The New NY Bridge Project

SUBJECT: Response to January 17, 2018 Letter

Your January 17th letter to Governor Cuomo regarding the design and operation of the Shared Use Path (SUP) of the Governor Mario M. Cuomo Bridge has been forwarded to me for response.

Figure 1.

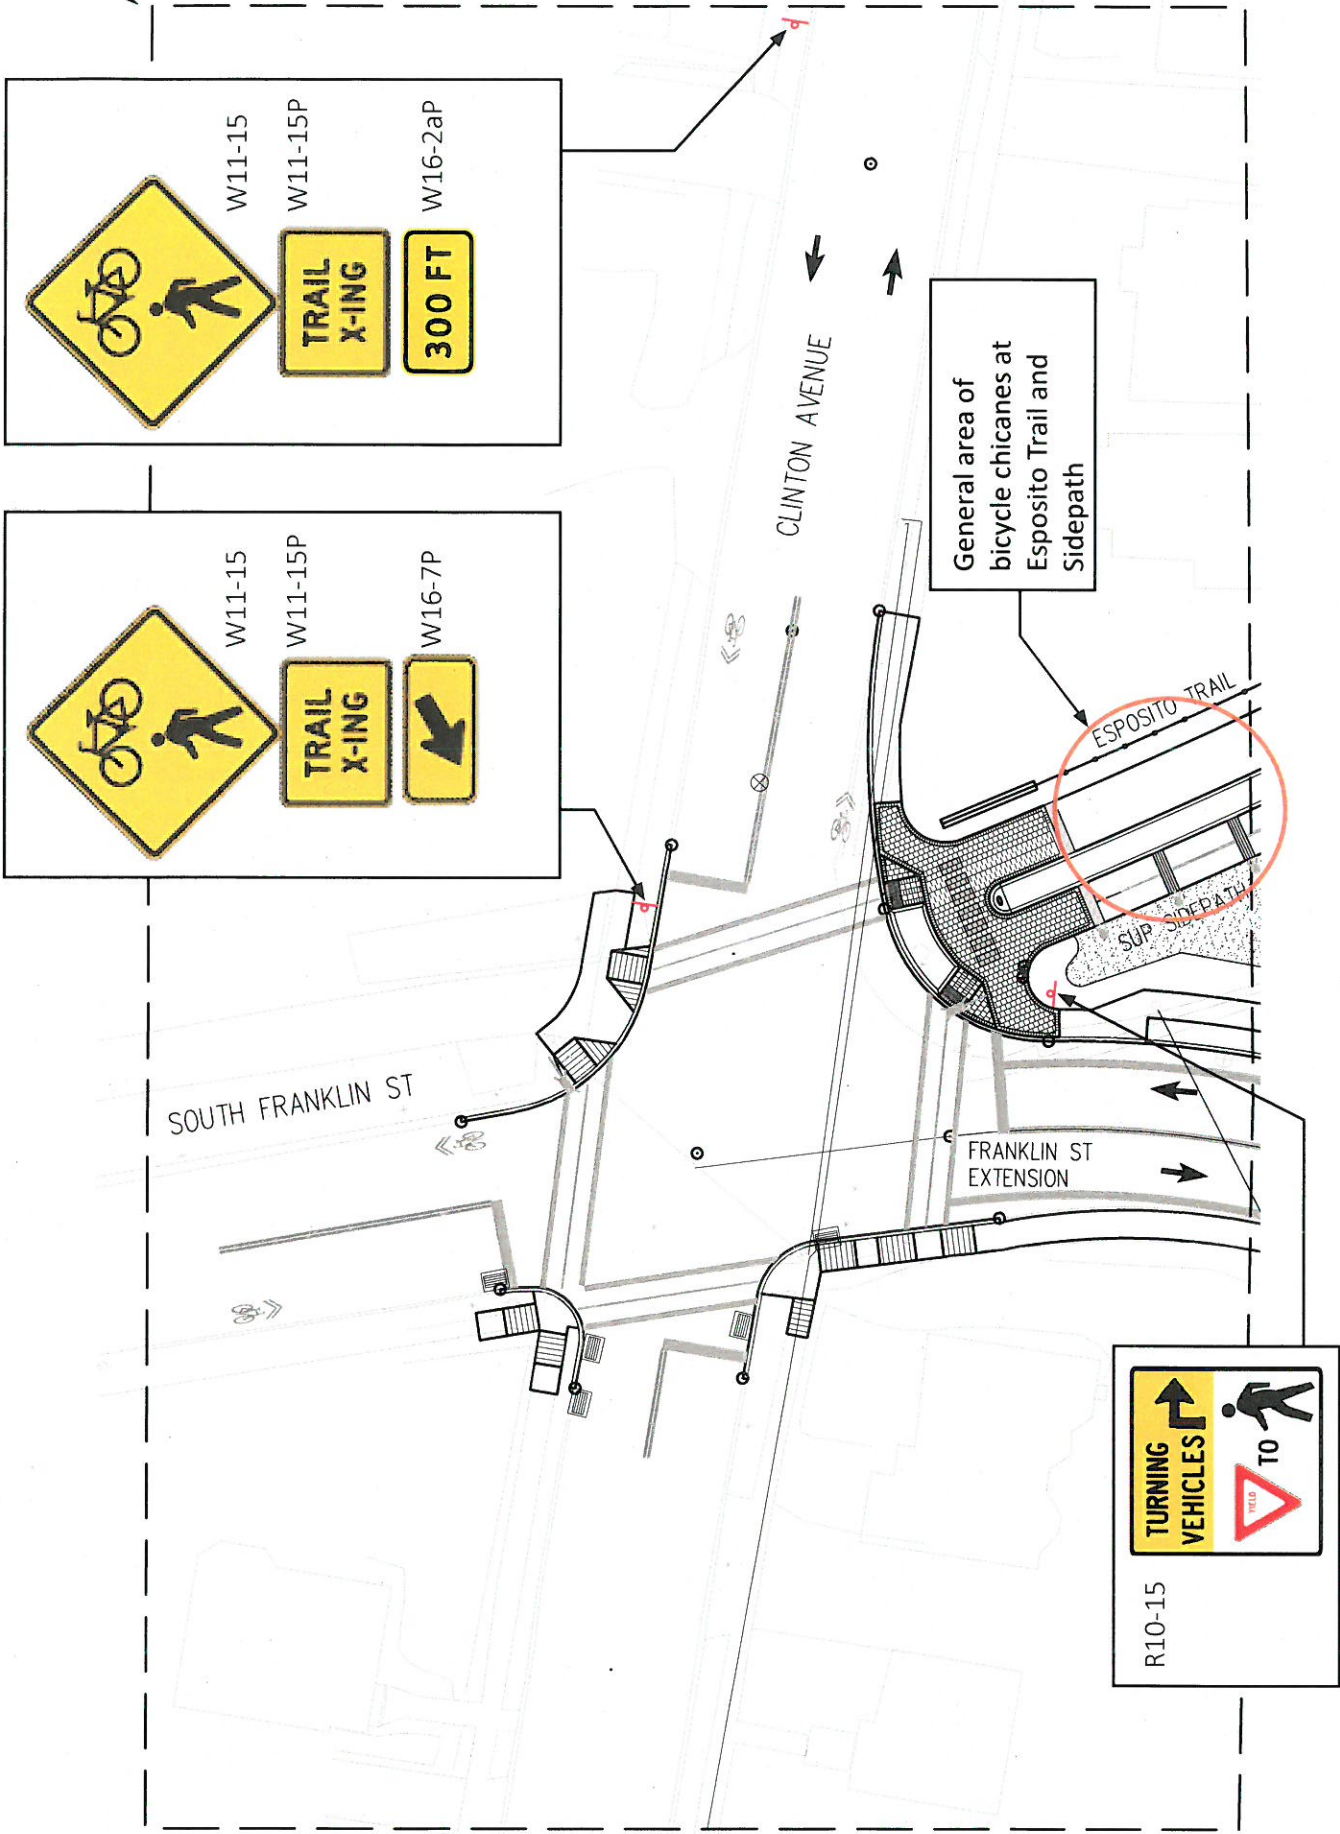
Your concerns about the signing and the design of the gates are well taken. The Authority will supplement the existing signage to include some of the signs you mention, including the "Turning Vehicle Yield Sign" at the roadway intersection and "Yield to Pedestrians" at the side path cross-over. The Authority will also replace the "in-line swinging" gate design with off-set, ADA-compliant bike chicanes (see attached plan) with requisite advance signage.
